NEW YORK CITY DEPARTMENT OF CORRECTION
Cynthia Brann, Commissioner

ADDENDUM No. 5 to PIN: 072202001CPD
Powerhouse Boiler Feed Water Treatment System Upgrade

Pursuant to section §3-04 of the Procurement Policy Board (PPB Rules, the Department of Correction (DOC) is issuing Addendum No. 5 to the solicitation for the services referenced above.

Drawing No.:
M302.00

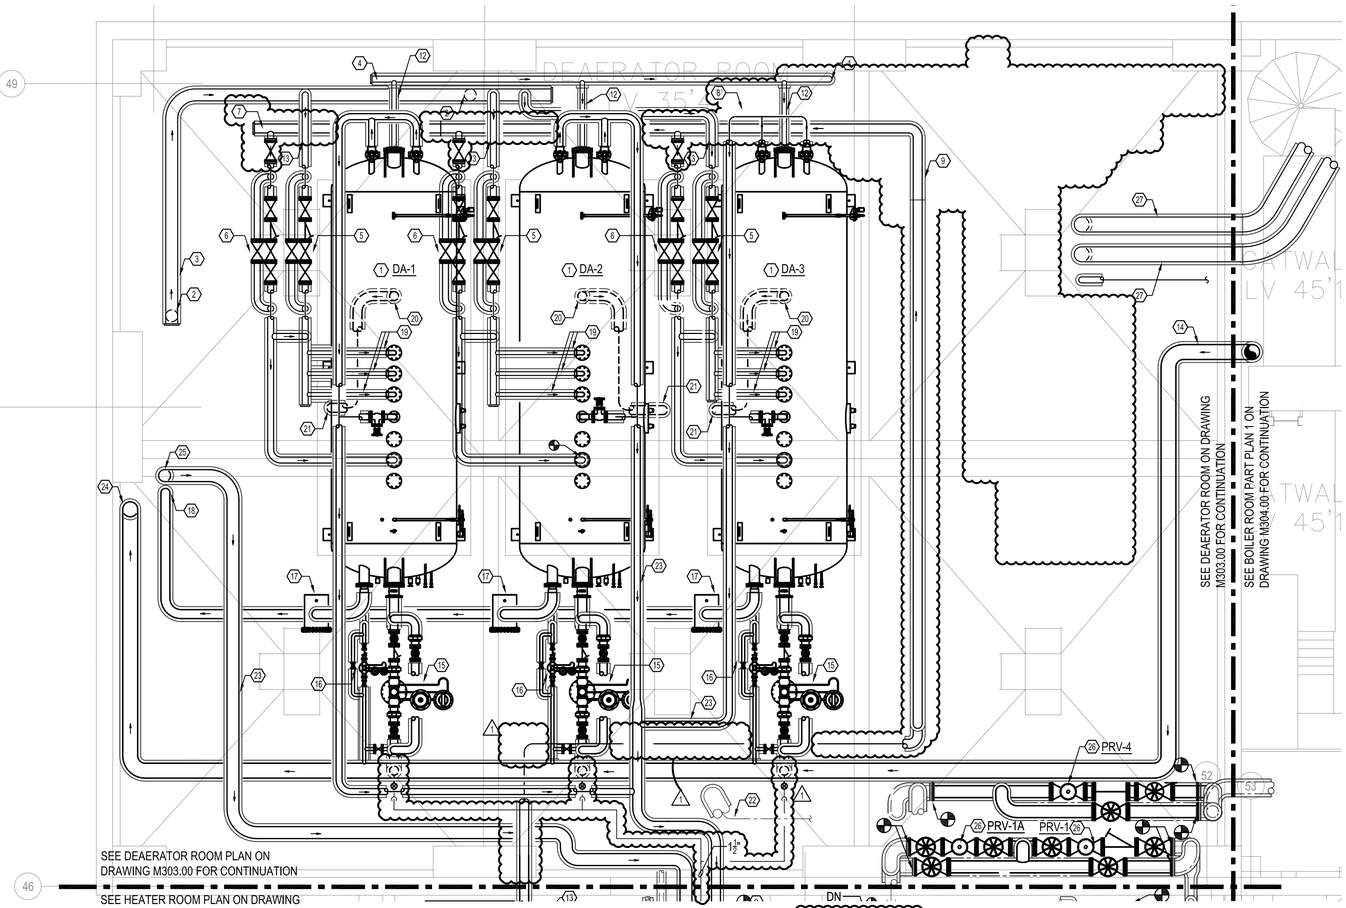
32) M302.00 – Revised RO and CIP location. Revised make up water, soft water and soft permeated water piping location. Revised tag notes.

Drawing No.:
M303.00

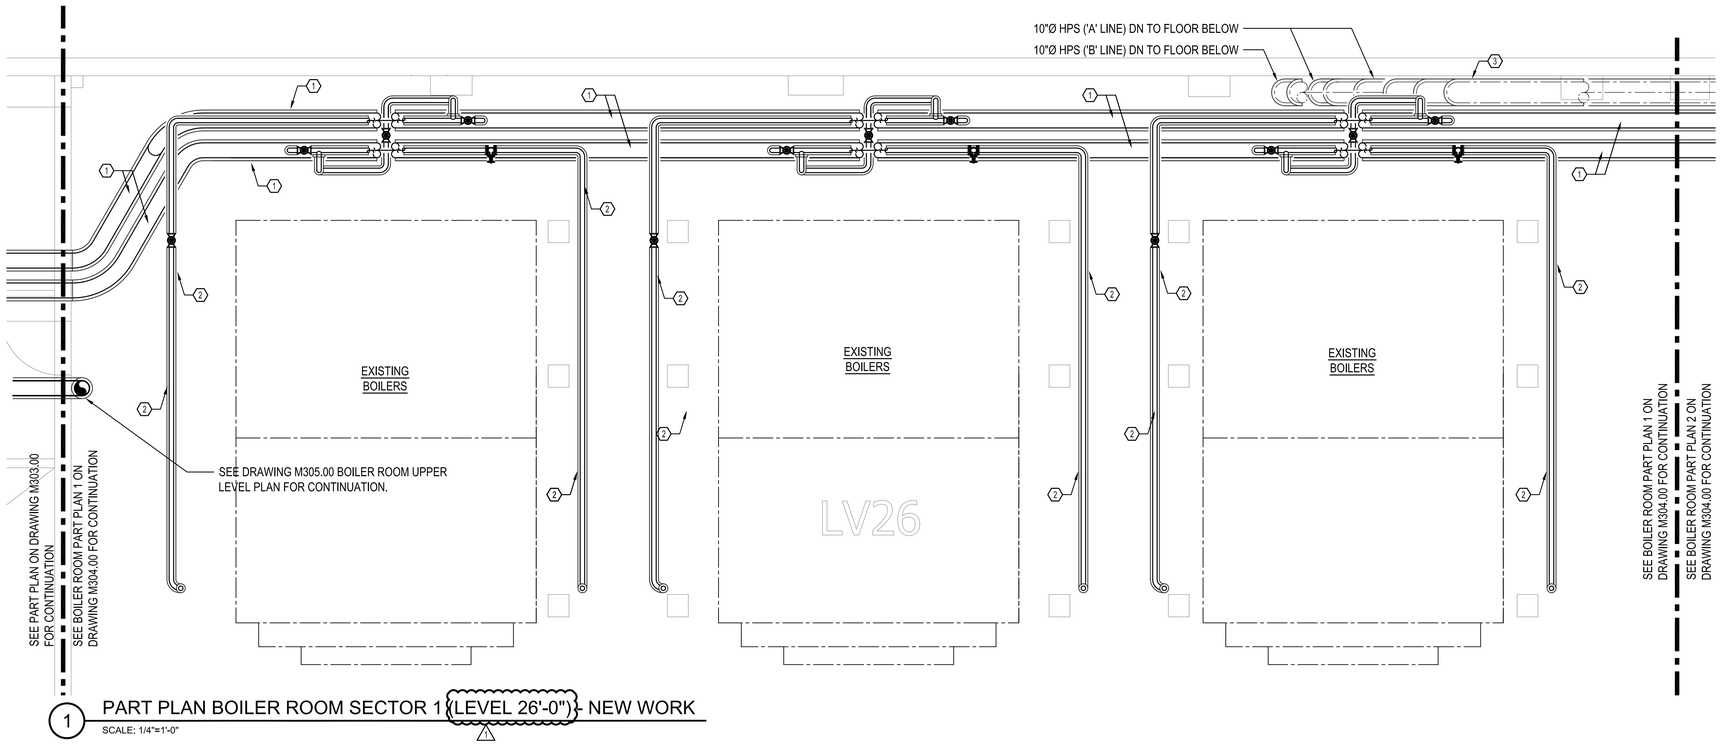
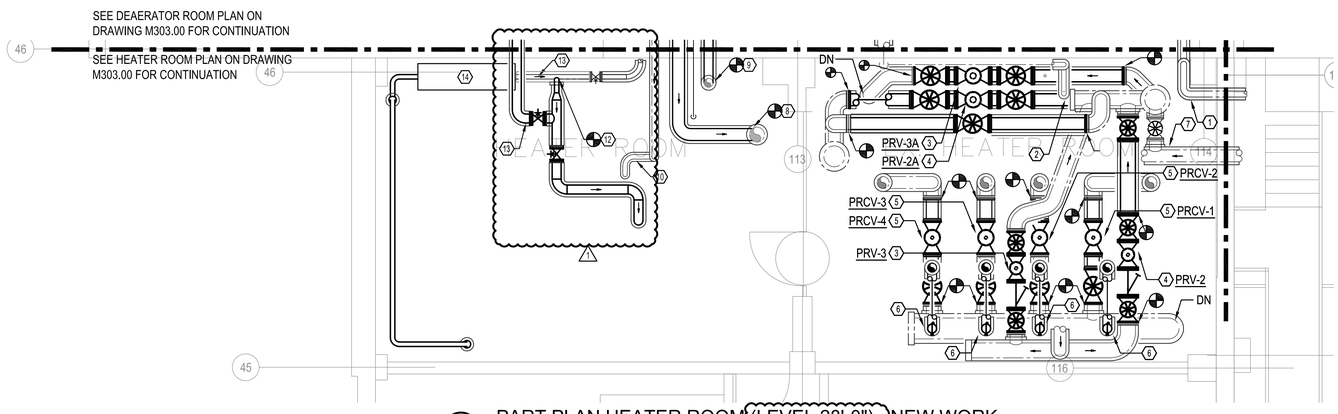
33) M303.00 – Revised RO and CIP location. Revised make up water, soft water and soft permeated water piping location. Revised tag notes.

47. Drawing M303.00 for the Deaerator tank shows two (2) each 4" modulating valve assemblies on each DA tank controller (total of three DA tanks) but drawing M504.00 shows only one 6" modulating valve assembly on each DA tank.

Drawing No.:
M402.00

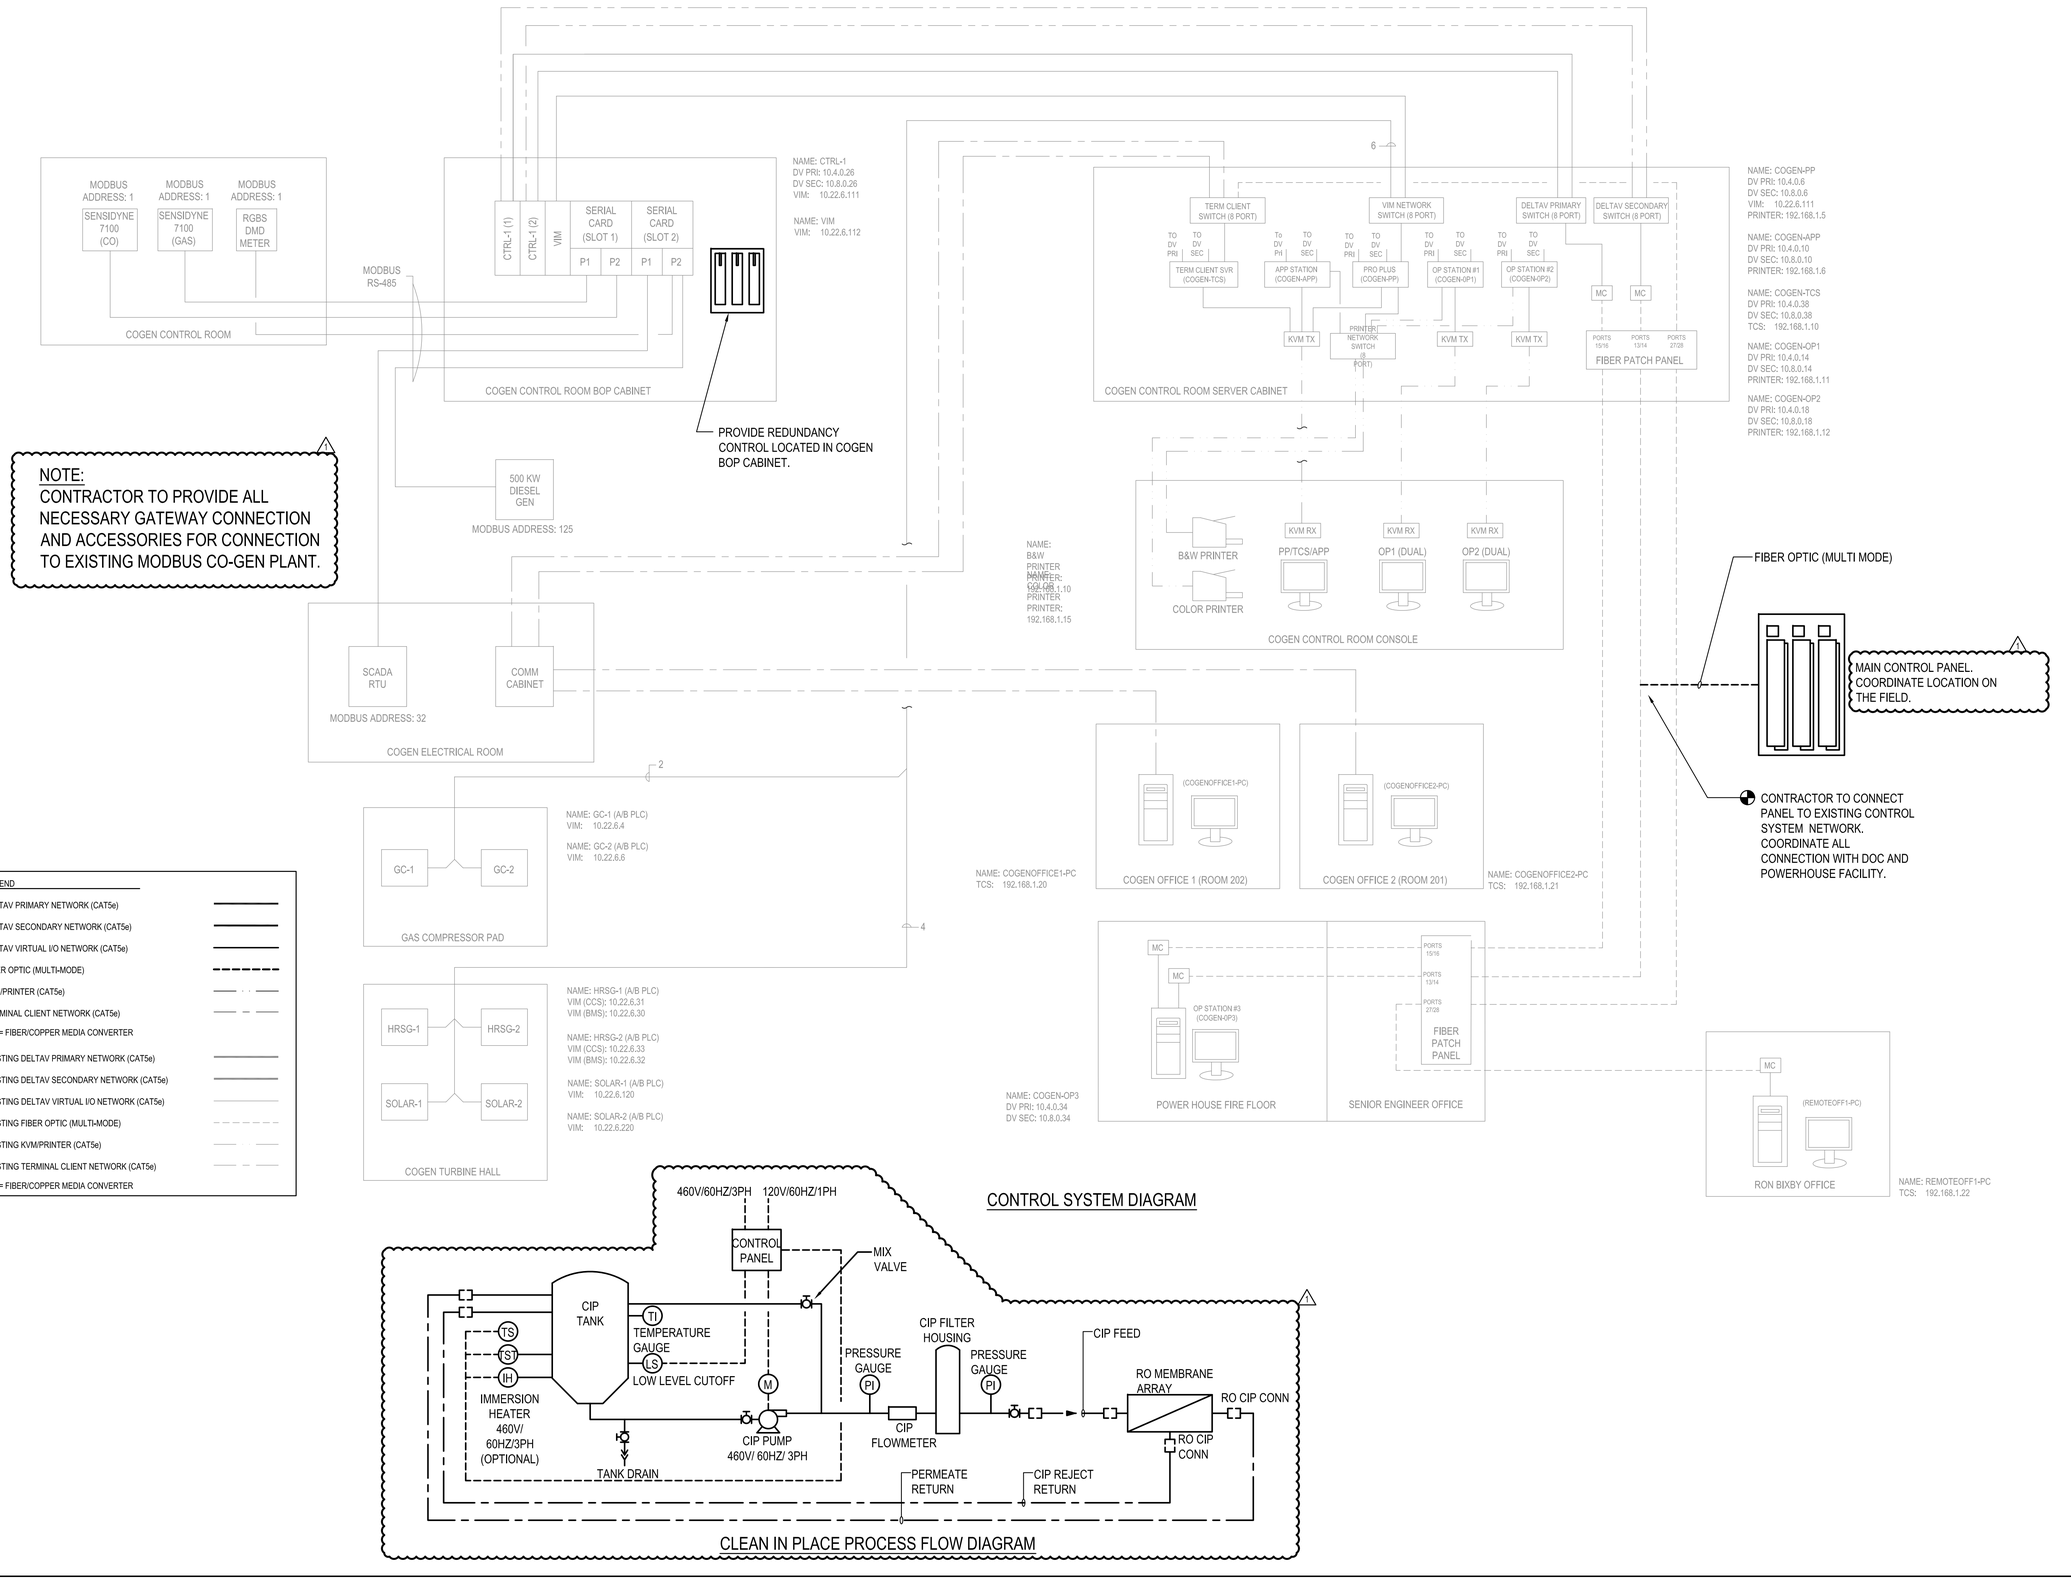
37) M402.00 – Revised RO and CIP location. Revised make up water, soft water and soft permeated water piping work.

33. Drawing M-402 shows 4" boiler feed discharge and a 10" boiler feed suction however drawing M-201 indicates a 6" boiler feed discharge (tag #24) and 6" boiler feed suction (tag #21). Also drawing M-201 (tag #22) indicates a 6" suction manifold, which cannot be correct. Please revise the drawings and coordinate the desired sizes.

Drawing Title:
HVAC
DETAILS SHEET
3 OF 4

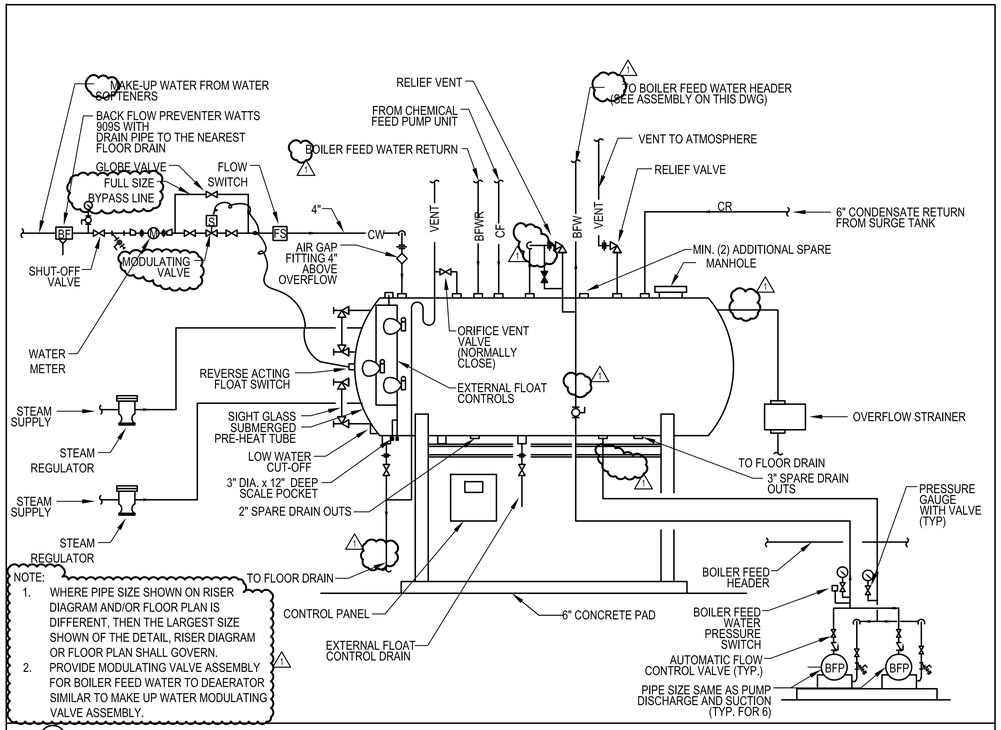
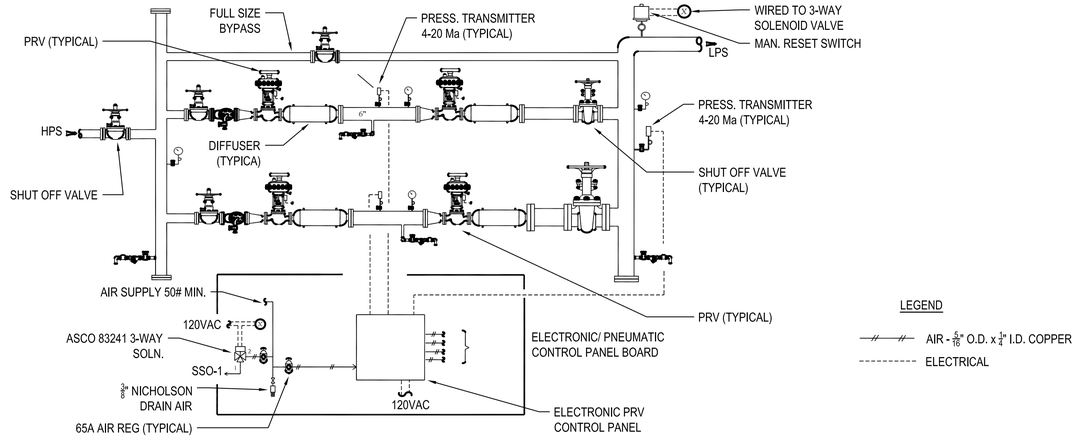
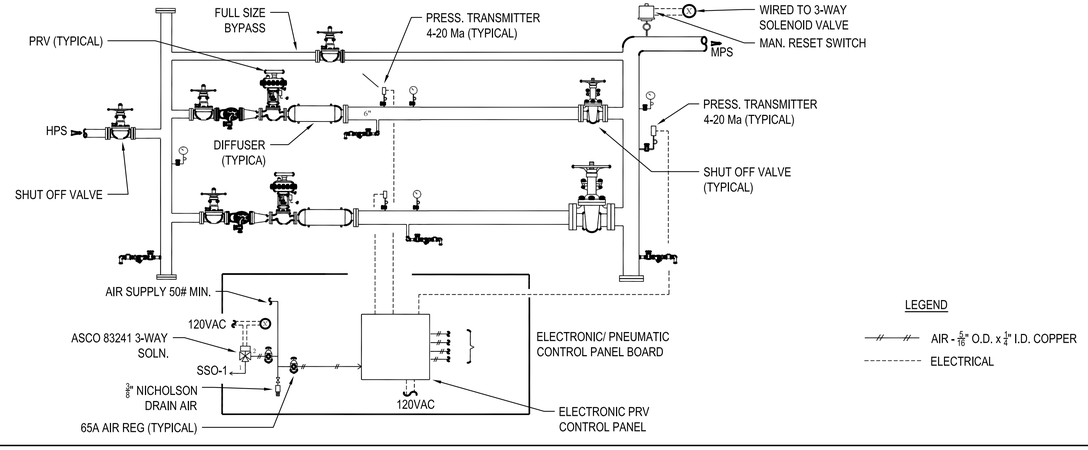
40) M503.00 – Removed detail 19. Added PRV station details.

40. Drawing M-503 (Detail 19) shows Schematic Automatic Boiler Surface Blowdown Piping. Is this part of the project? It is my understanding that the boilers are not part of this project and the existing boilers are water tube boilers so this would not apply. Please confirm.

61. Please clarify if detail #19 schematic automatic boiler surface blowdown piping on drawing M-503 is to be included as this scope is not indicated on mechanical plans.

Drawing No.: DE101.00

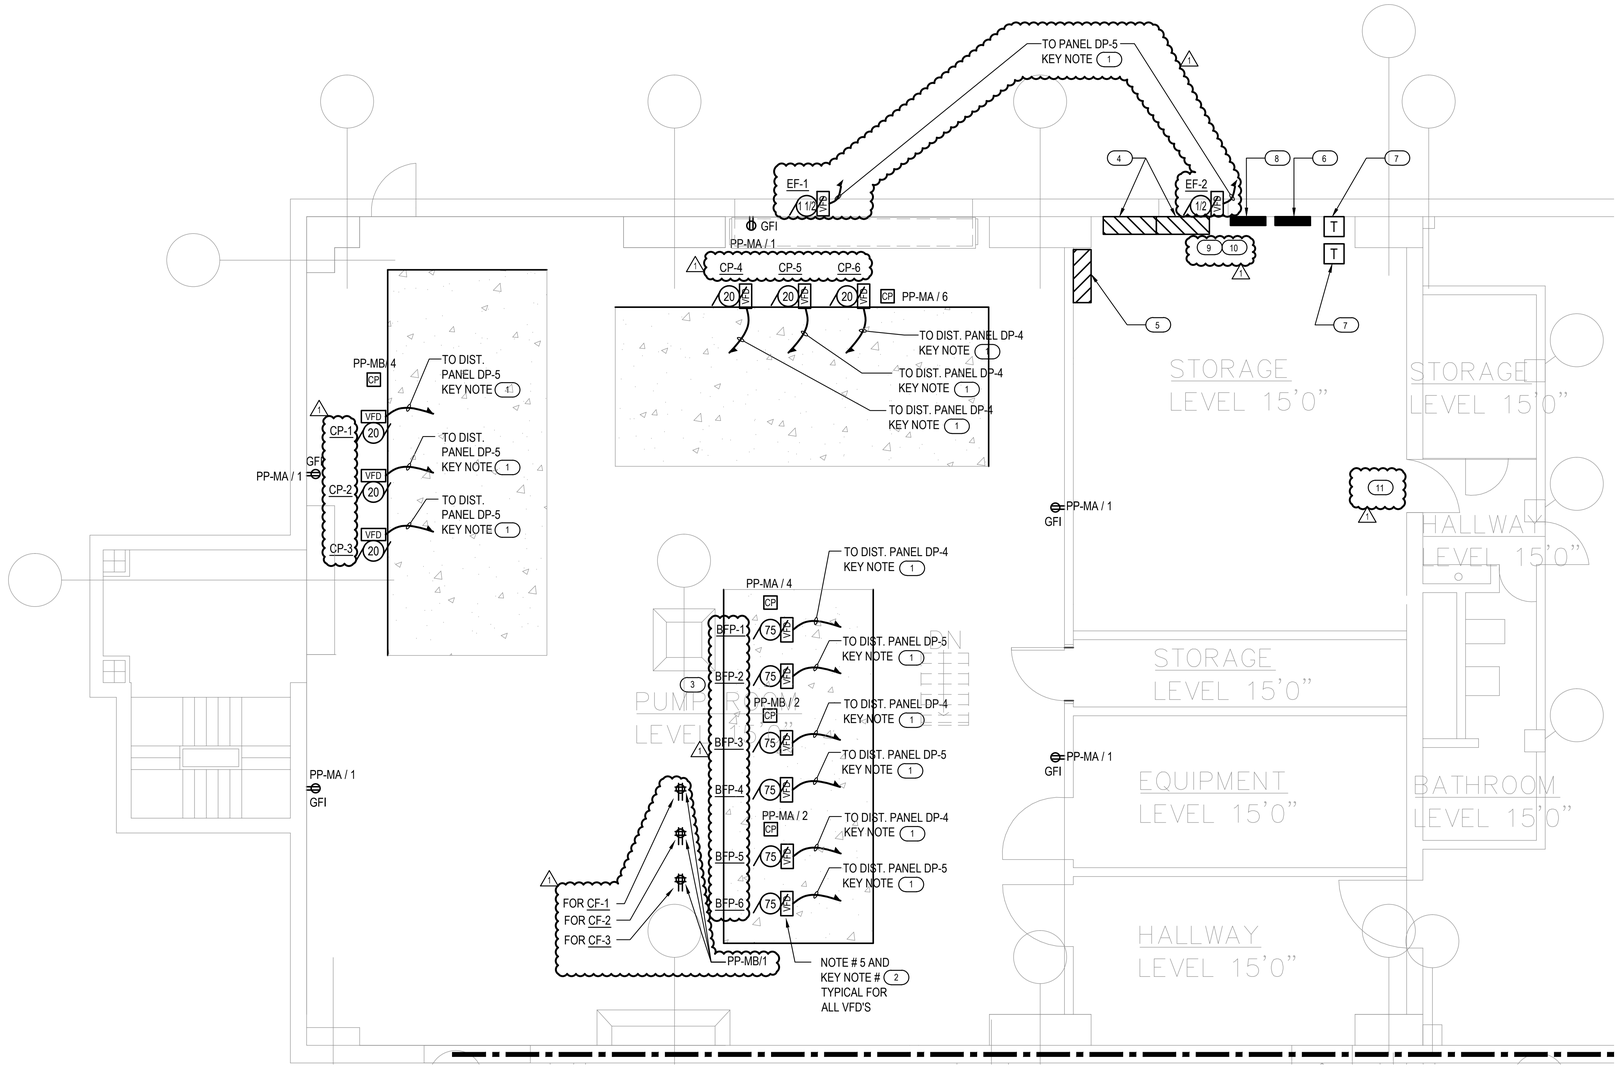
43) DE101.00 – Added fans removal, revised key note.

Drawing No.: E201.00

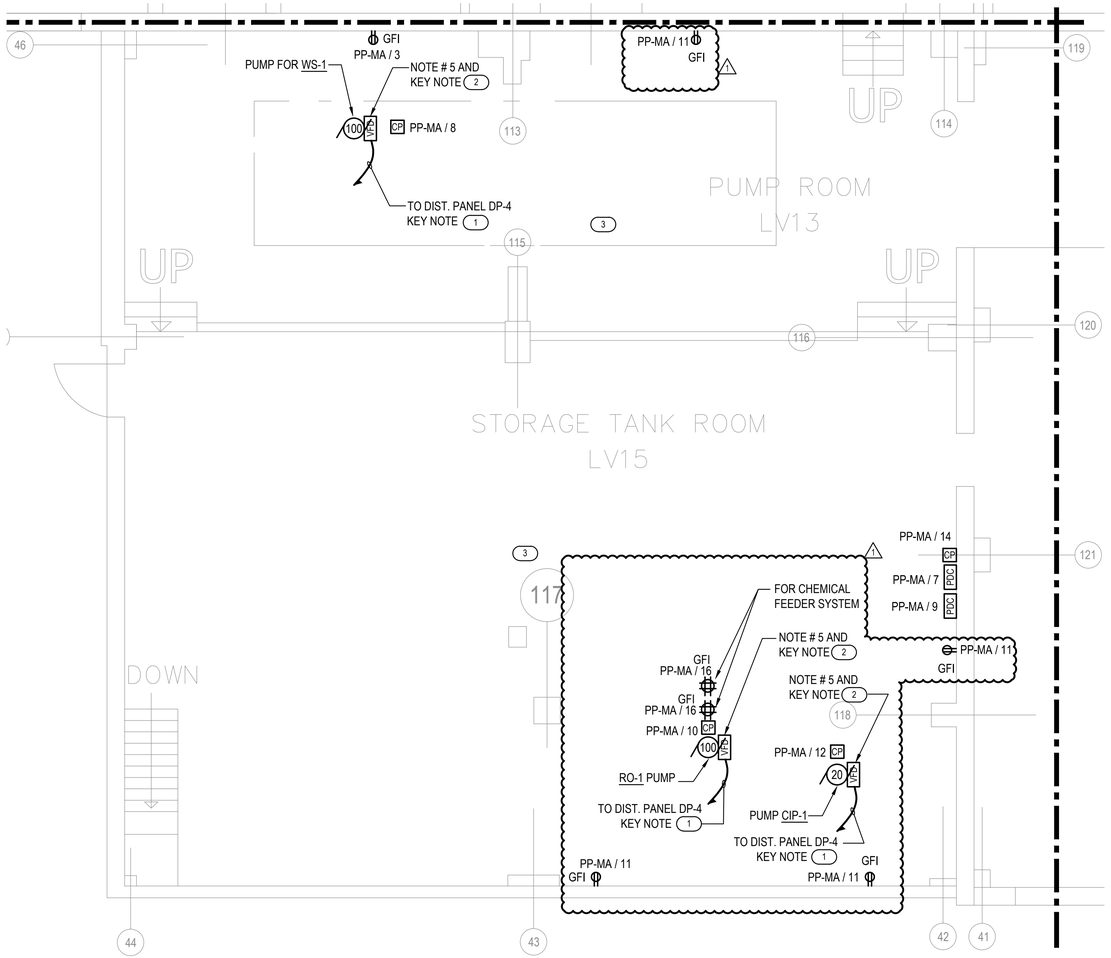
44) E201.00 – Added fan work, revised key notes.
